REMARKS

I. Status of the Application

The status of the Subject Application is as follows: Claims 1-78 are pending in the Subject Application. Claims 1-8, 13-23, 40, 47-55, 61, and 65-73 stand rejected by the Official Action under 35 U.S.C. § 112, second paragraph. Claims 9-12, 24-39, 41-46, 56-60, 62-64, and 74-78 have been withdrawn from consideration pursuant to Applicant's election without traverse of claims 1-8, 13-23, 40, 47-55, 61, and 65-73 in its response to the action of March 26, 1999.

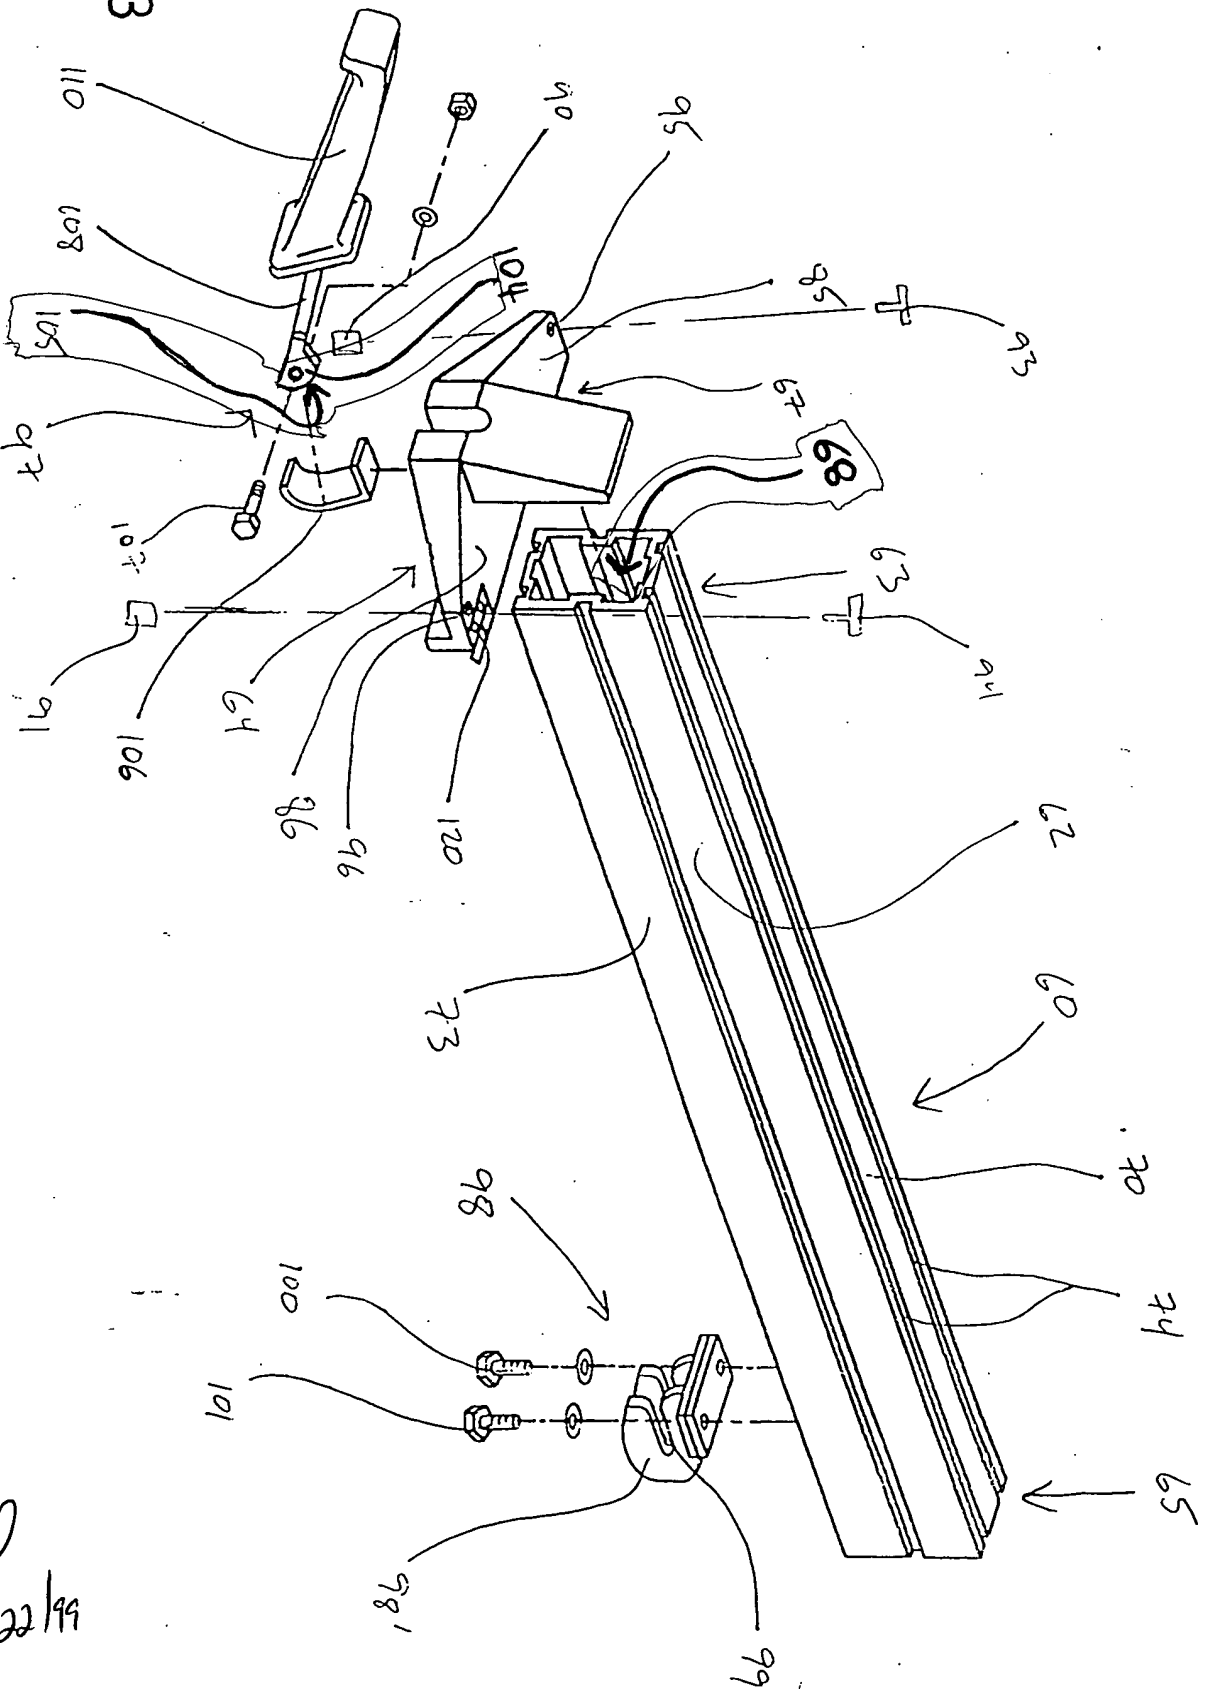
The drawings have been objected to under 37 C.F.R. § 1.83(a). In particular, the Official Action asserts that, "[i]n Figures 1 and 2, the occurrence of '62' with the arrowhead lead line appears to be inaccurate, and it seems that it should be changed to --65-- since it represents the outfeed end (opposite which represents the infeed end)." Responsive to this objection, Applicant respectfully requests replacement of original Figures 1 and 2 with replacement Figures 1 and 2 which depict, in pertinent part, the arrowhead lead line labeled "62" in the original drawings as "65".

FIG. 13

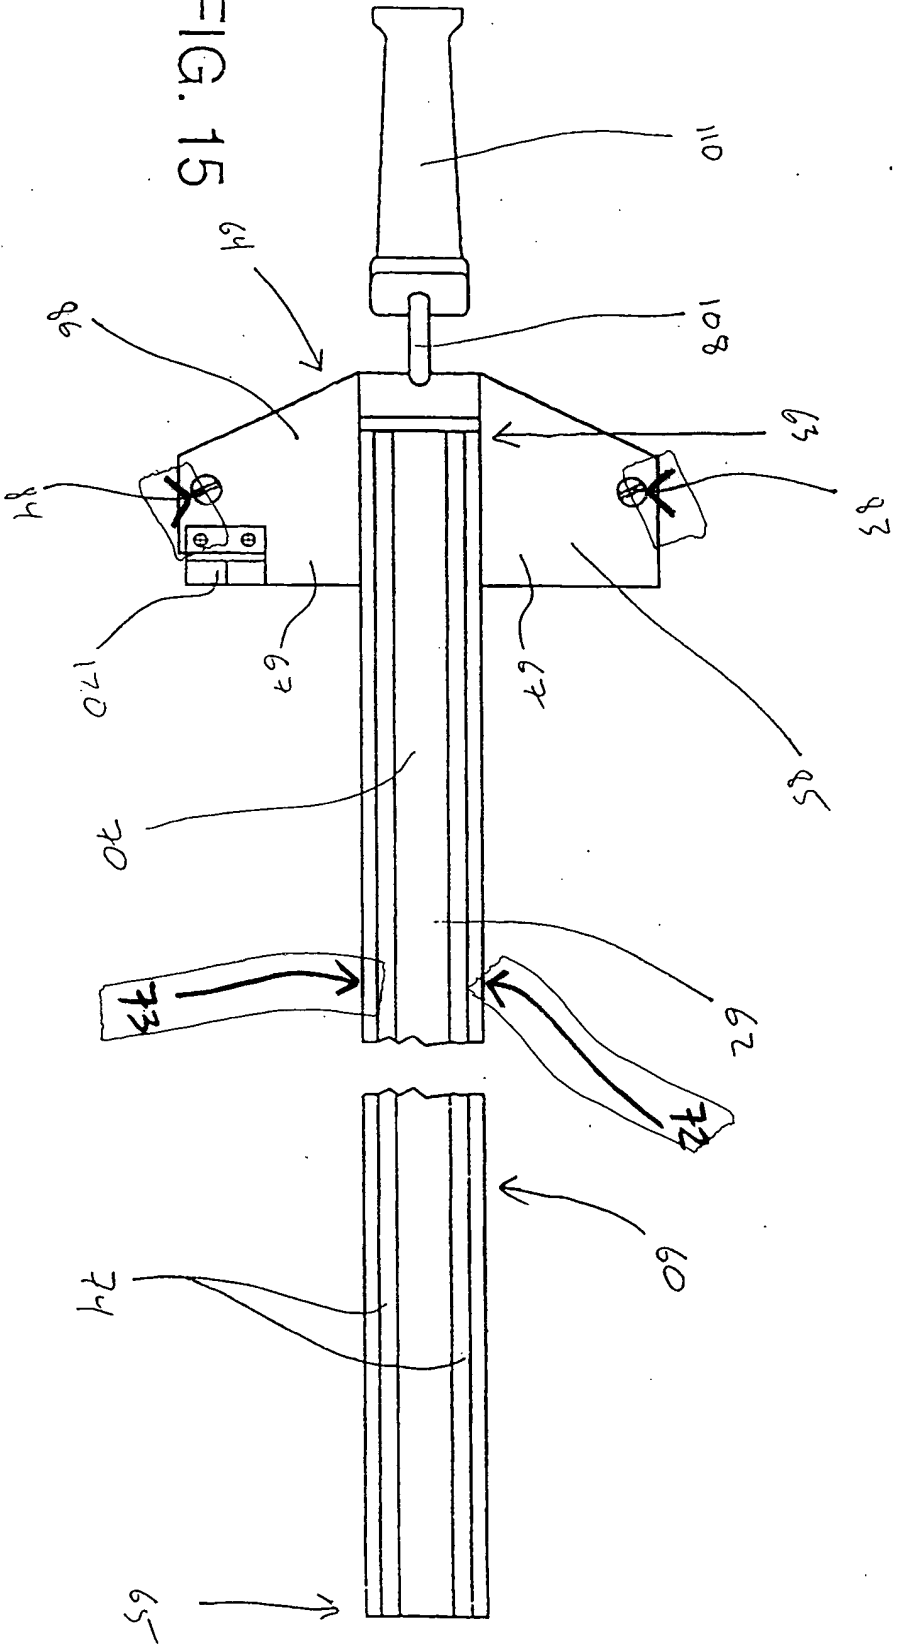
In addition, the Official Action asserts that, "[i]n Figure 13, '105' appears to be inaccurate, and it seems that it should be changed to --104-- and --105-- should be added with a lead line extending to the rounded cam surface of clamp 104 to correspond to the specification

(e.g., see page 22, line 6); also, it seems that '104' along with its lead line should be deleted for clarity; further, it seems that --68-- with a lead line extending to the inner region at the infeed end 63 of body 62 should be added for clarity." Responsive to this objection, Applicant respectfully requests replacement of original Figure 13 with replacement Figure 13 which depicts, in pertinent part, "105" with a lead line extending to the rounded cam surface of clamp 104, "104" with a lead line extending to clamp 104, and "68" with a lead line extending to the inner region at the infeed end 63 of body 62.

FIG. 15

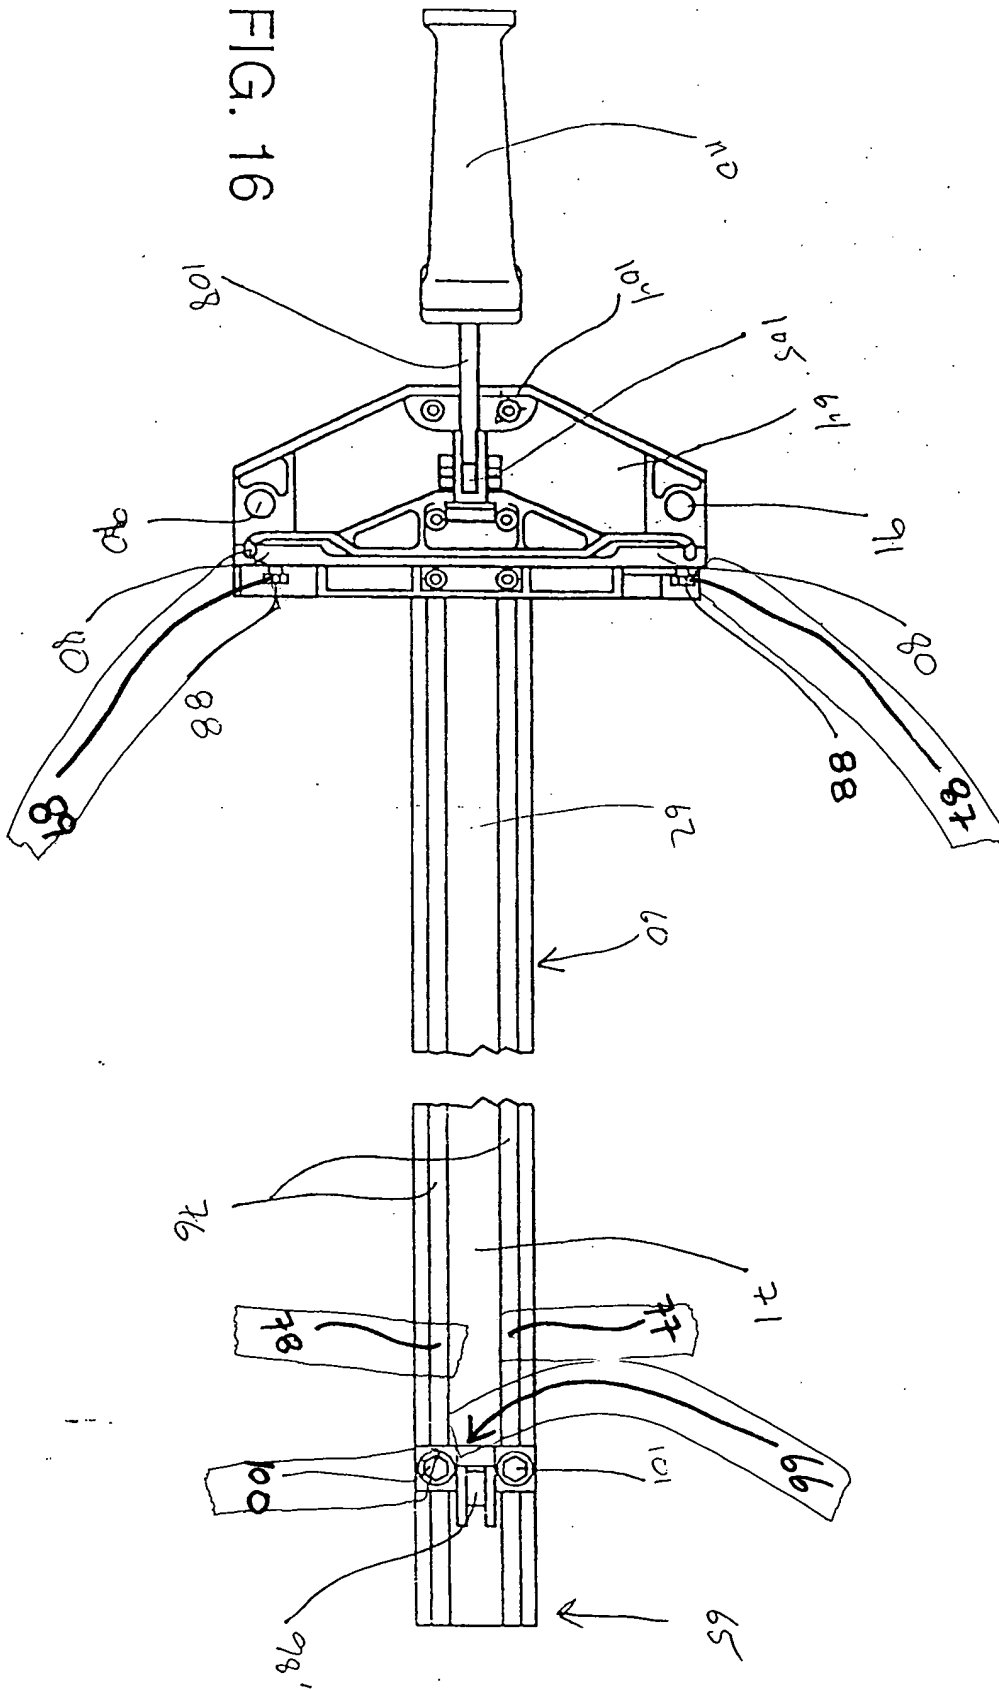
Further, the Official Action asserts that, "[i]n Figure 15, numerals --72-- and --73-- should be added for clarity; further, the lead line for each of numerals 83 and 84 should end in an arrowhead since these numerals generally represent a height adjustment mechanism." Responsive to this objection, Applicant respectfully requests replacement of original Figure 15 with replacement Figure 15 which depicts "72" and "73" with lead lines extending to the side faces of the body 62 and the lead lines labeled "83" and "84" ending in an arrowhead.
